REPORT TO THE CITY OF VISALIA HISTORIC PRESERVATION ADVISORY COMMITTEE

SUBJECT: Historic Preservation Advisory Committee Item No. 2022-16: A request by Lovejot Singh and Jason Scott to demolish and rebuild an existing convenience store within the D-MU (Downtown Mixed Use) Zone. The project site is located at 540 North Court Street (APN: 094-261-026)

Exterior Elevations

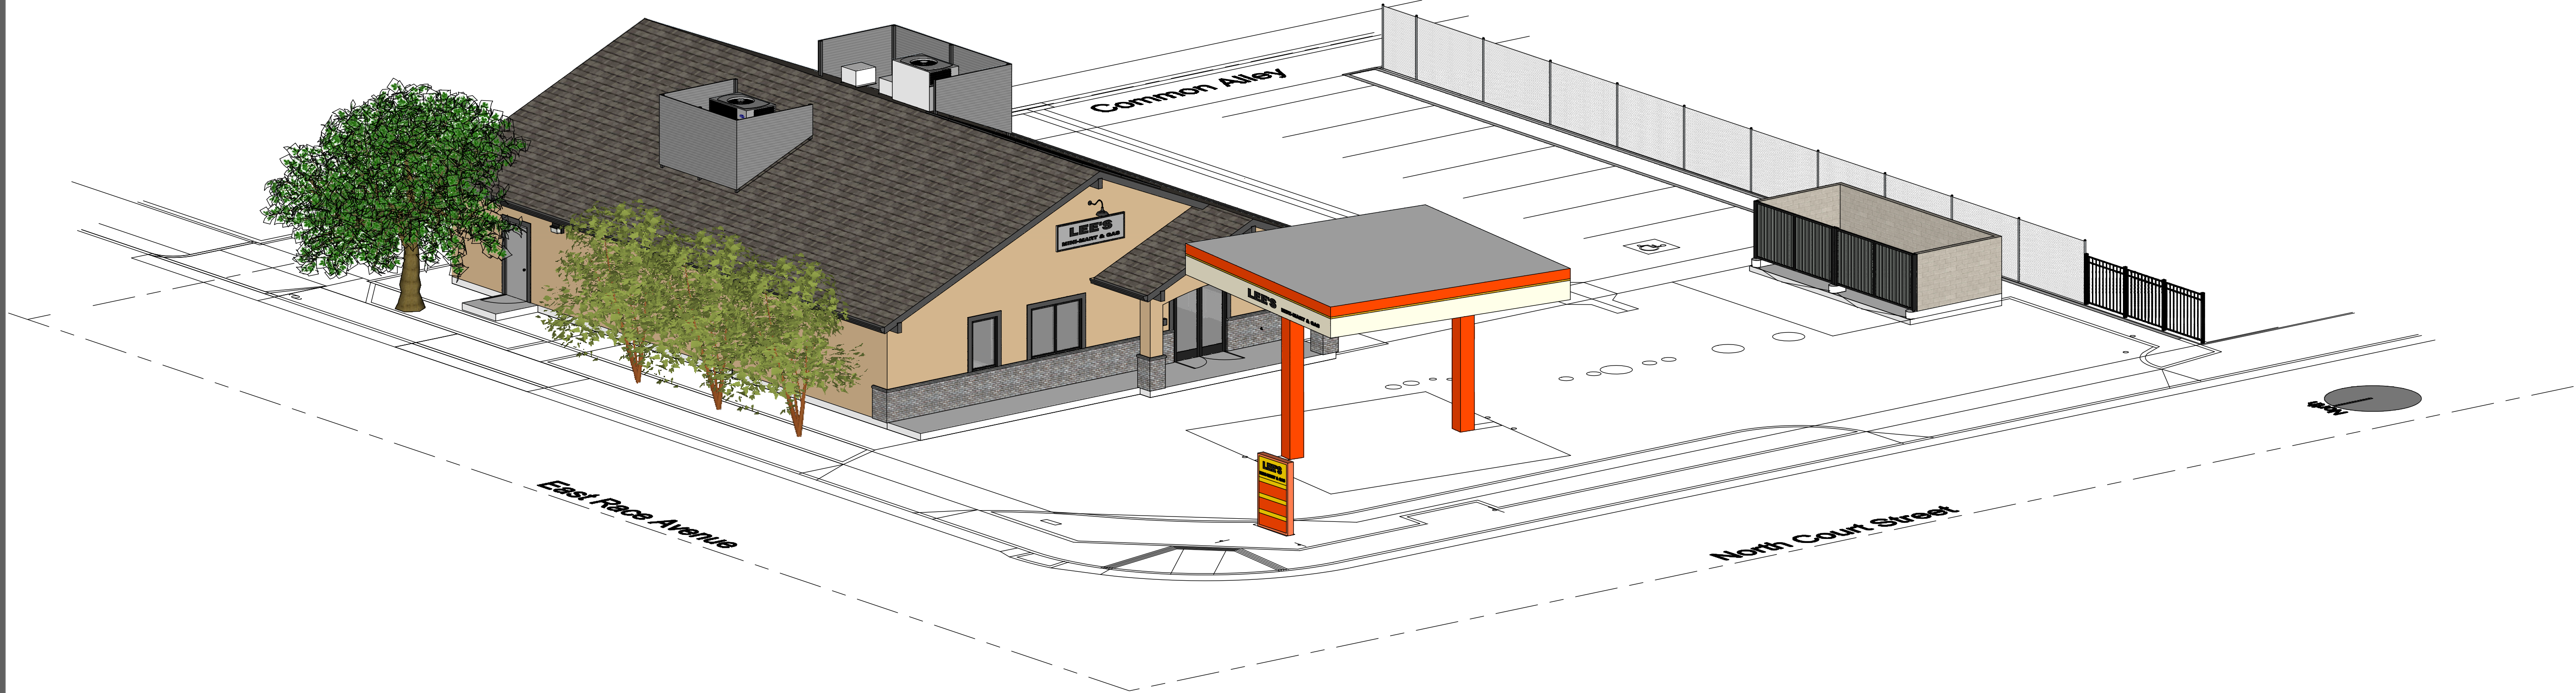
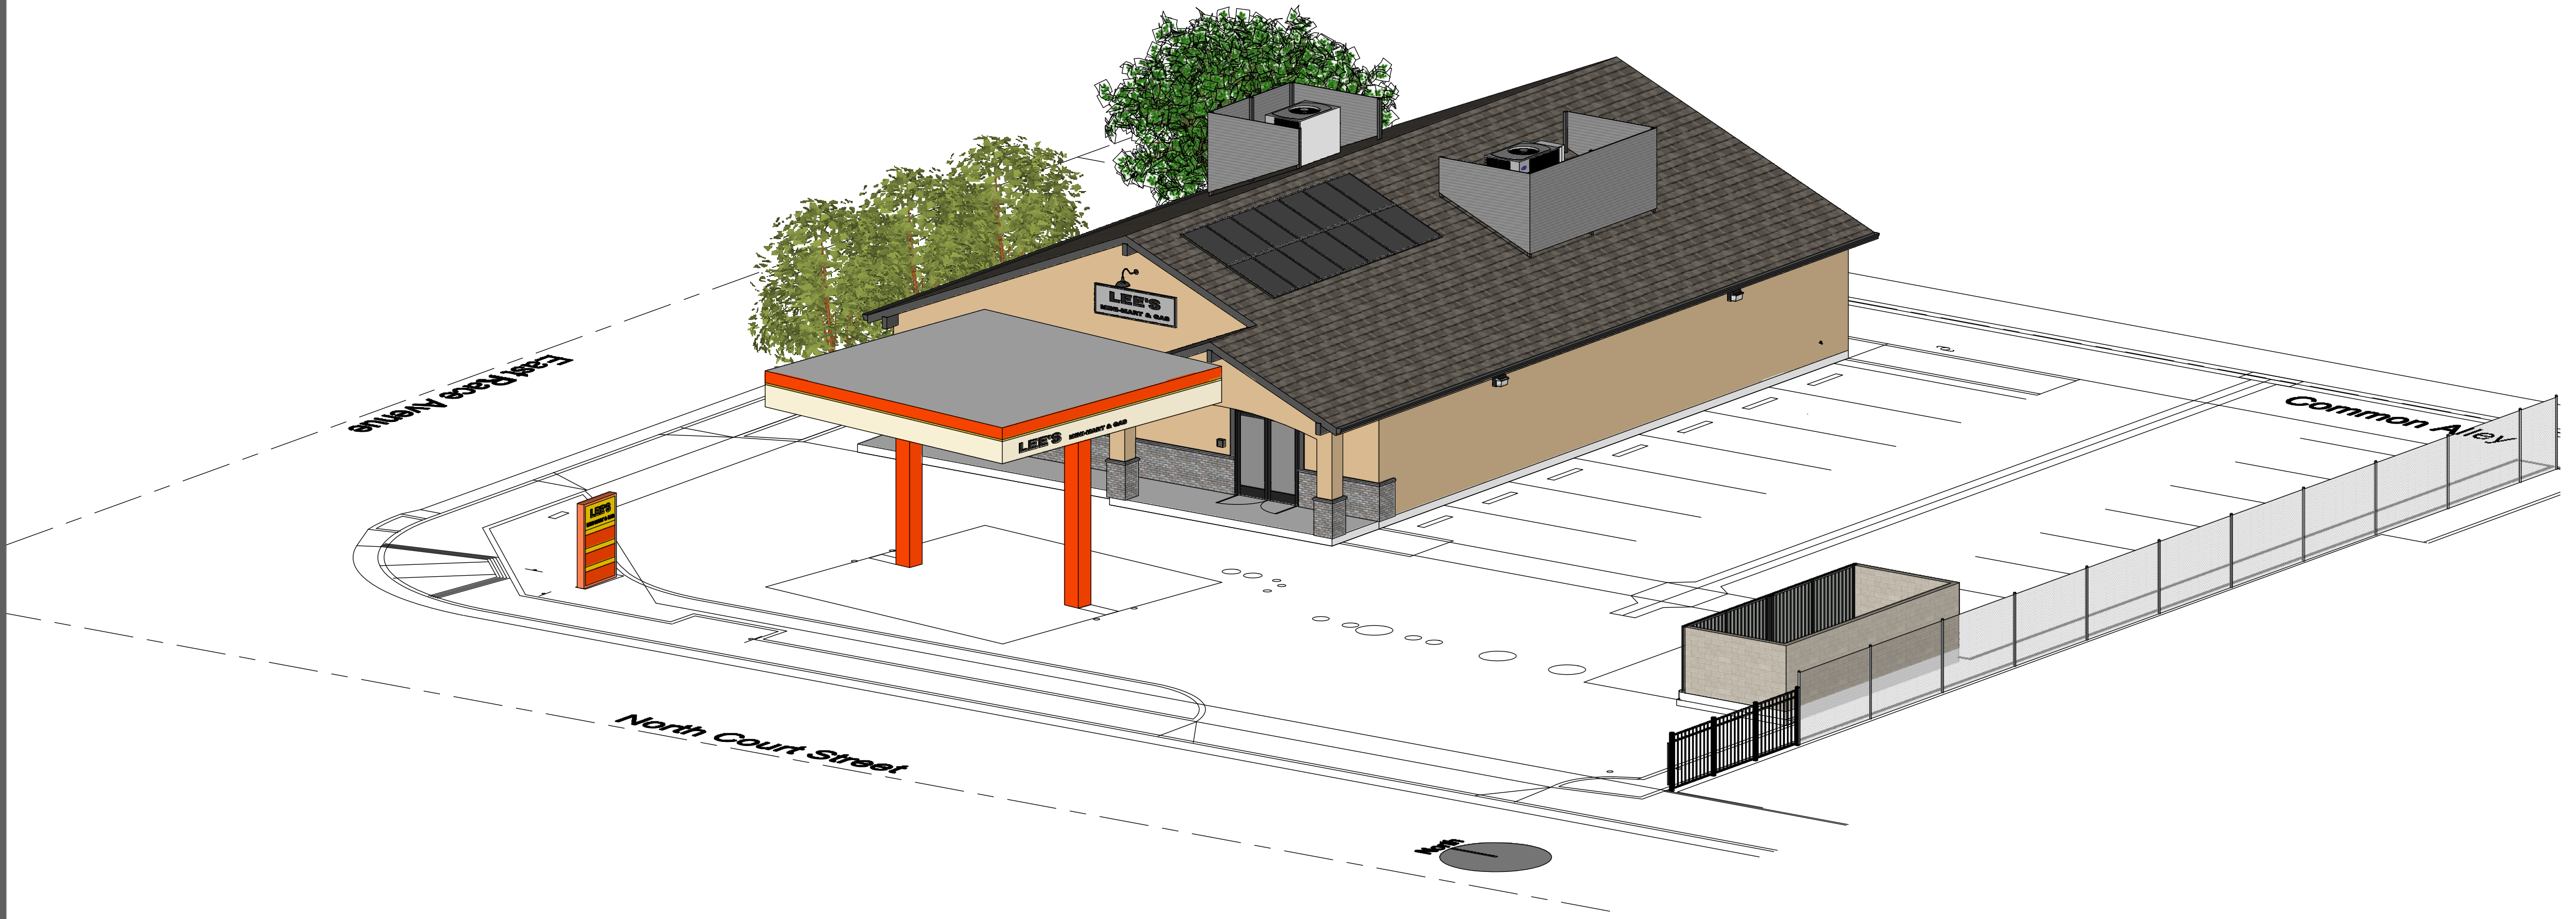
Staff has determined that the architectural elements provided in Exhibit “D” are insufficient to meet the requirements of Items C (Relationship of Materials and Textures), E (Walls of Continuity) and G (Directional Expression of Front Elevations). Design elements are focused solely on the Court Street frontage, neglecting the northern facing Race Street frontage that will also be highly visible to the public. Proposed features such as faux brick and windows should be increased and spread throughout the other building exteriors. Materials such as aluminum screening material would be highly out of step with typical materials found in the Historic District and the immediate surrounding area. Lastly, the proposed structure is missing a second gable roof feature facing either north or south. As shown in Exhibit “G”, the structures immediately to the south, contain a second gable to provide additional visual interest to the structures.

- Placement of an additional roof gable along the northern building exterior, facing Race Street.
- Removal of aluminum screening material in favor of a screening feature more in keeping with the Historic District such as, but not limited to, faux dormer windows or wood screening material.
- Placement of faux brick along the bottom sections of the northern and southern building exteriors.
- Placement of additional windows along the northern building exterior.
- Placement of muntins within all windows and doors.
- Placement of additional ornamental features on the northern and southern building exteriors, to break up the mass of blank walls.

2. That the site shall be developed consistent with the building elevations in Exhibit "D", except as modified by placement of the architectural elements listed below:

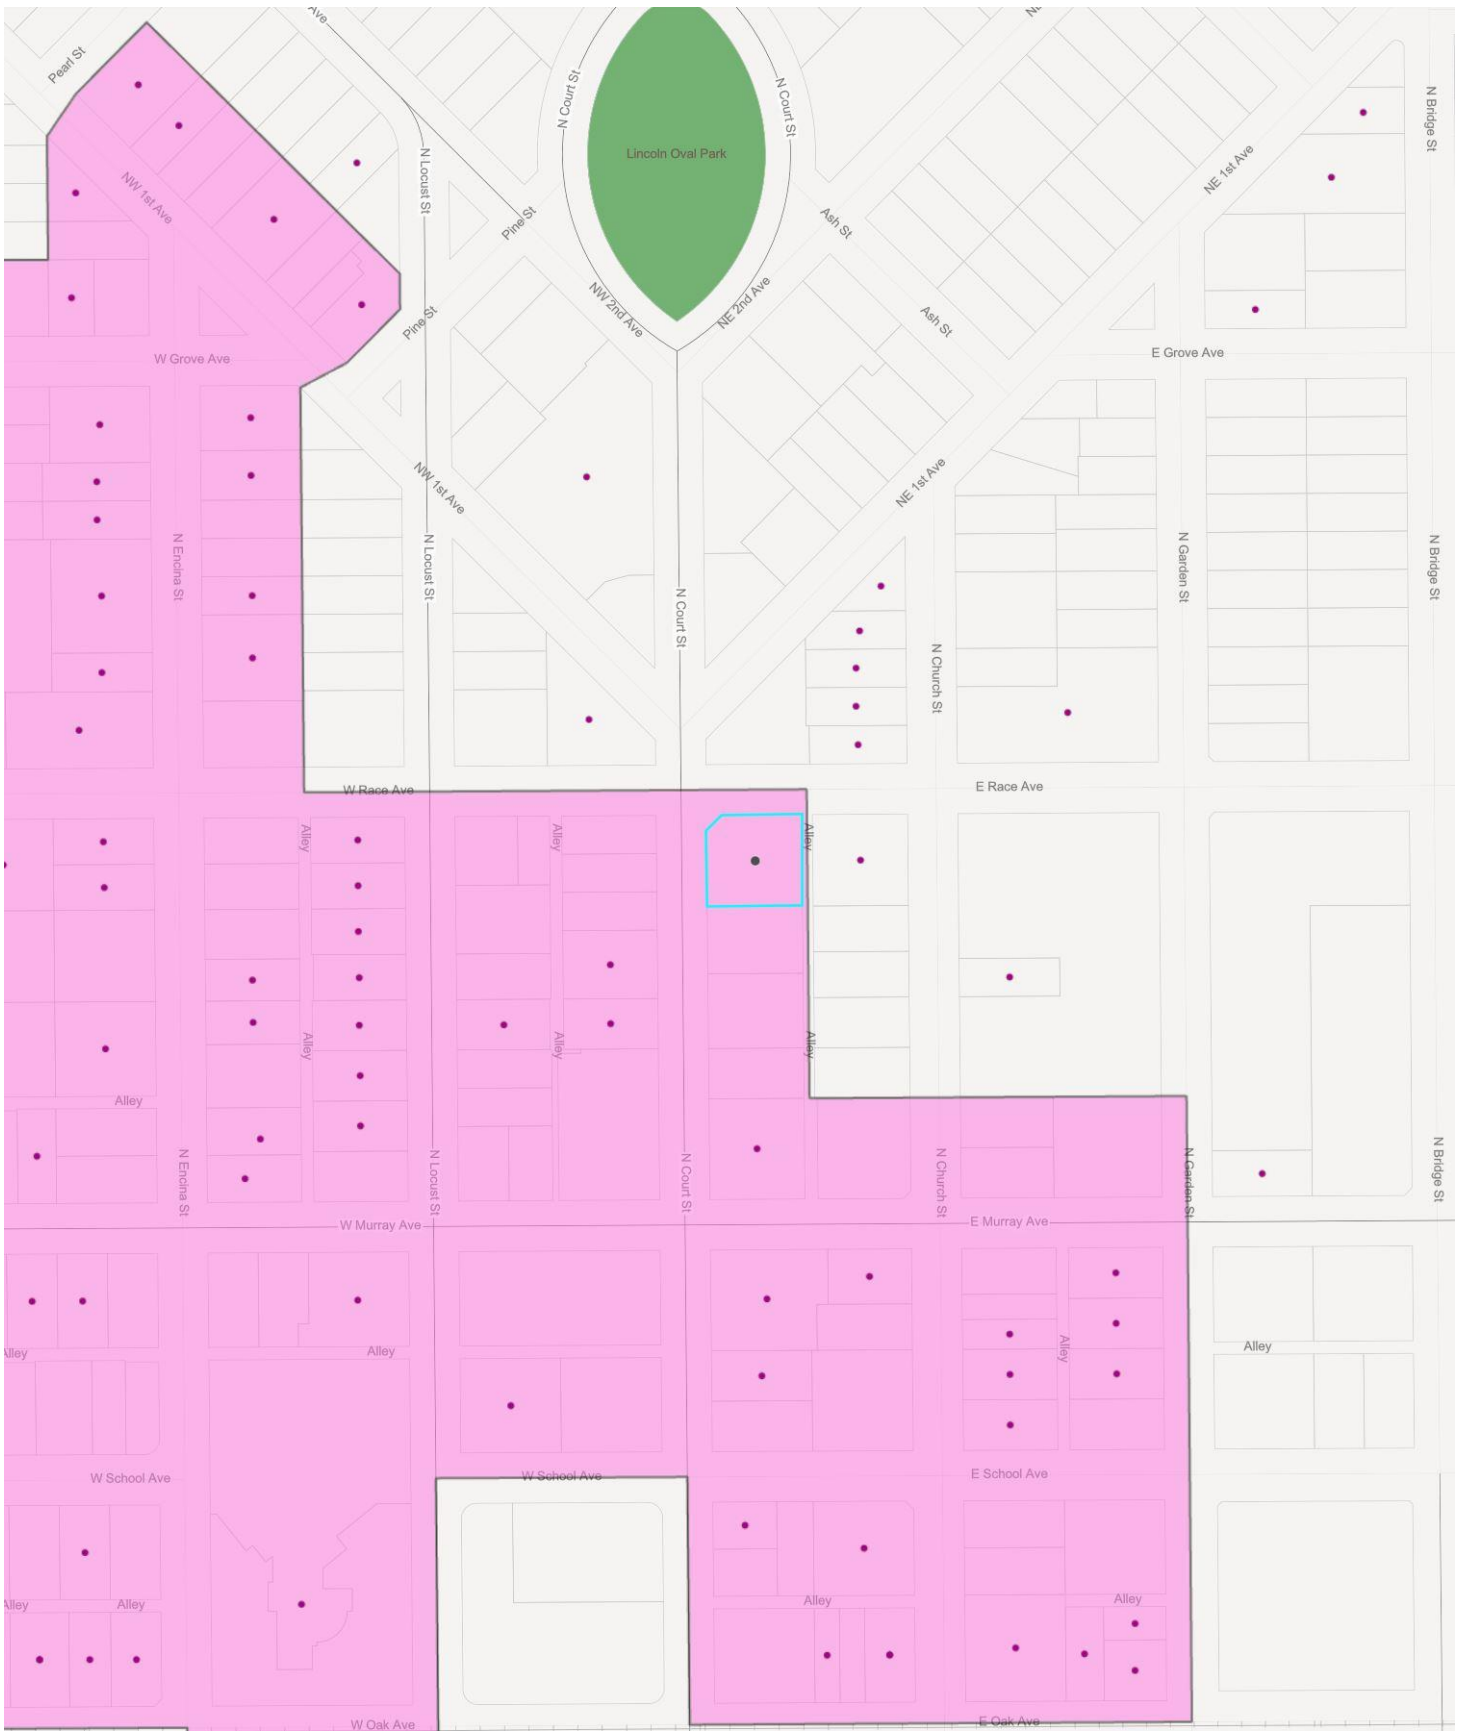
Comment Solid Waste recommends rotating the enclosure west a few degrees to allow for direct STAB services from Court St. Customer to include dimensions in front of enclosure to verify the required 38' of clear space required. Solid waste services will be required to include trash, recycle, and organic collection services, per State of California's mandatory recycling laws (AB-341 & AB-1826). Enclosure gates are required and must open 180 degrees and clear all curbing. Cain bolts shall be included to secure gates when open.
